RENESAS TECHNICAL UPDATE

Product Category	MPU & MCU	Document No.	TN-16C-A231A/E	Rev.	1.00
Title	Errata to R32C/157 Group User's Manual: Hardware		Information Category	Technical Notification	
Applicable Product	R32C/157 Group	Lot No.	Reference Document	R32C/157 Group User's Manual: Hardware Rev. 1.10 (REJ09B0507-0110)

This document describes corrections to the R32C/157 Group User's Manual: Hardware, Rev. 1.10. The corrections are indicated in red in the list below.

Figure 7.1 Clock Generation Circuitry

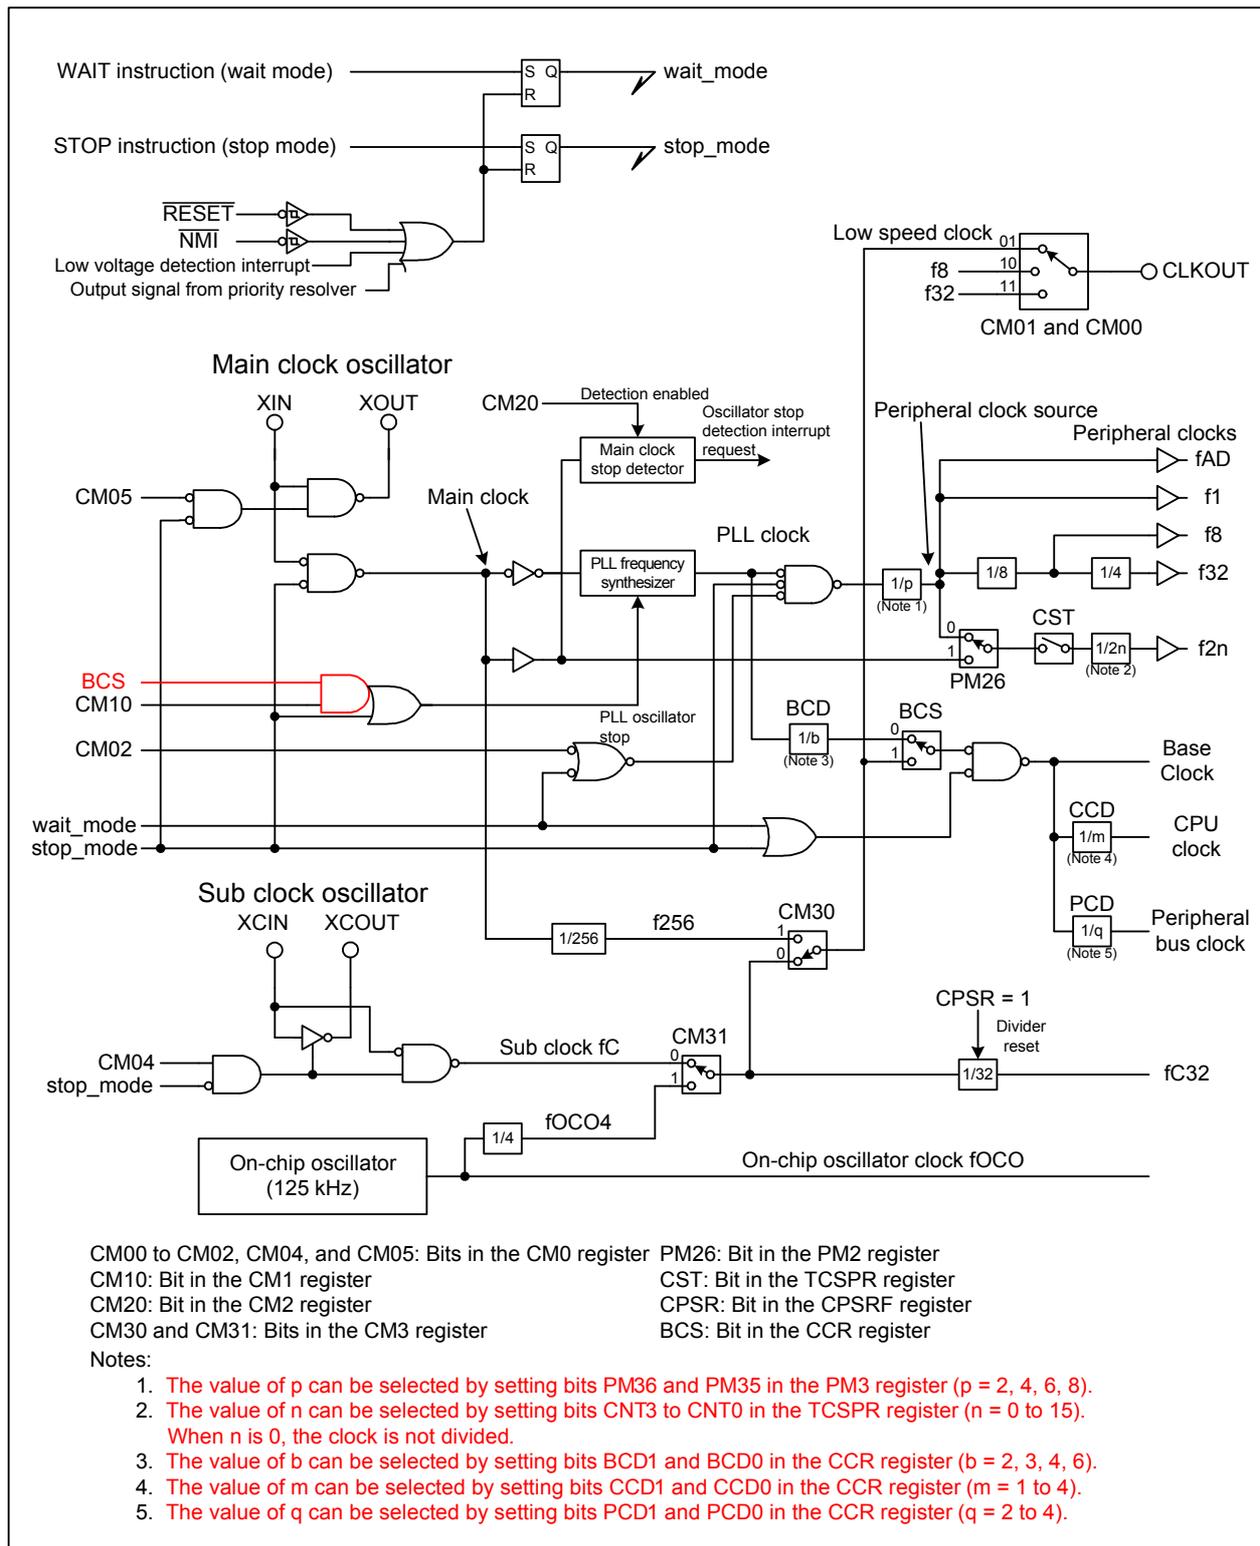
•Page 104 of 639, Figure 7.1 is corrected as follows:

Figure 20.1 CRC Calculator Block Diagram

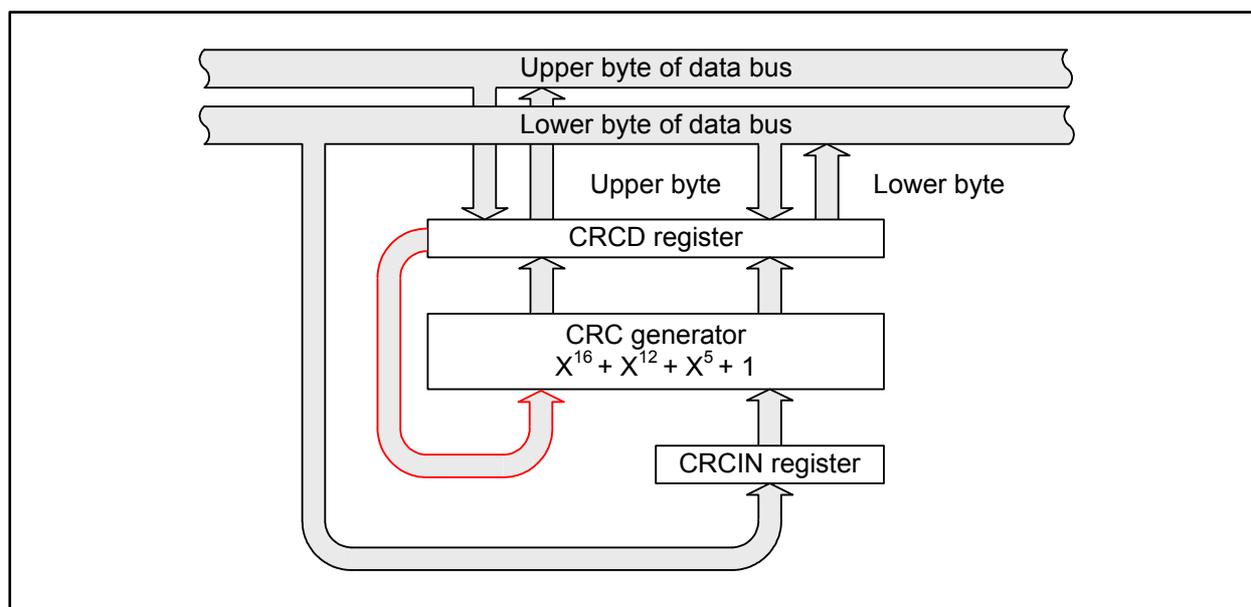
- Page 326 of 639, Figure 20.1 is corrected as follows:

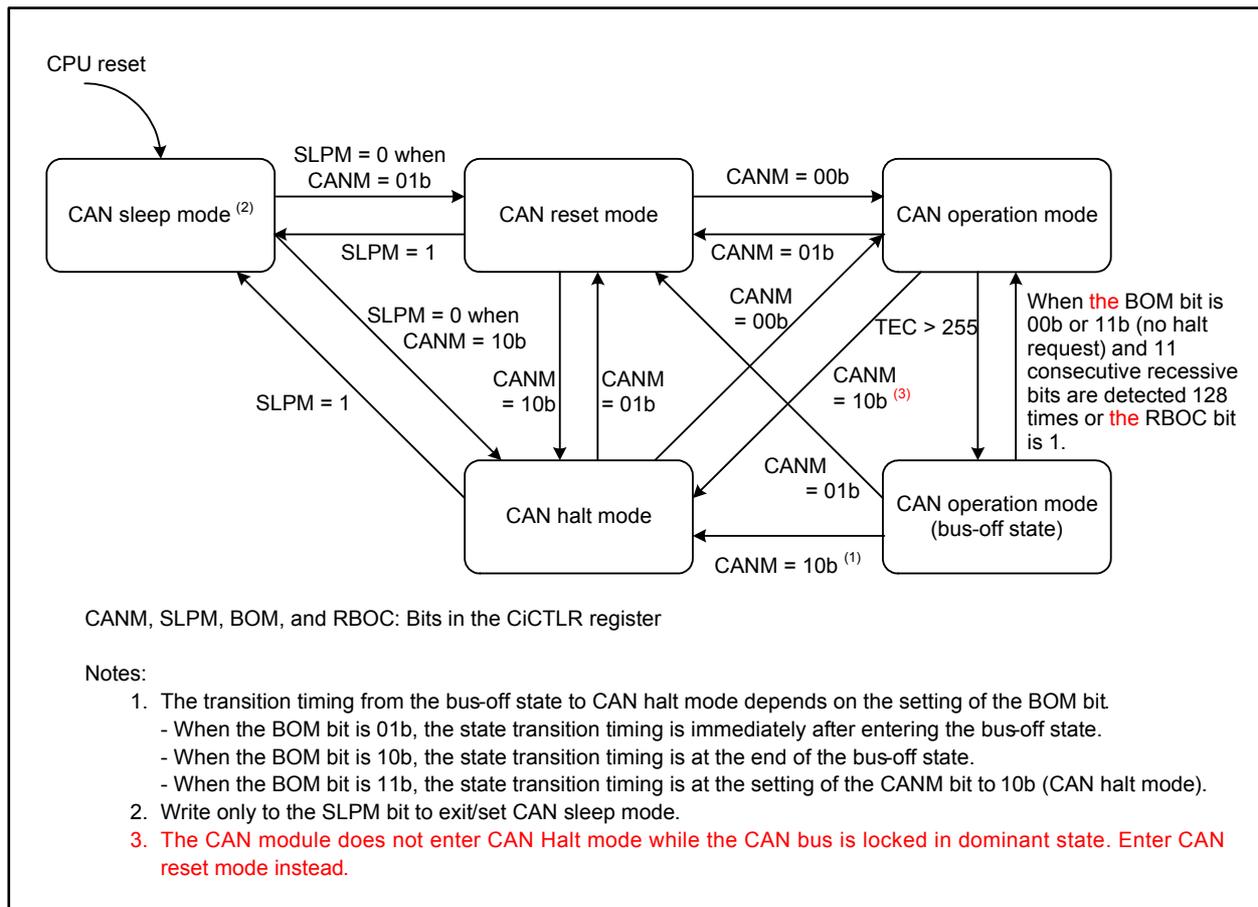
•Page 492 of 639, Note 3 is added to Figure 25.34 as follows (refer to TN-16C-A229A/E):
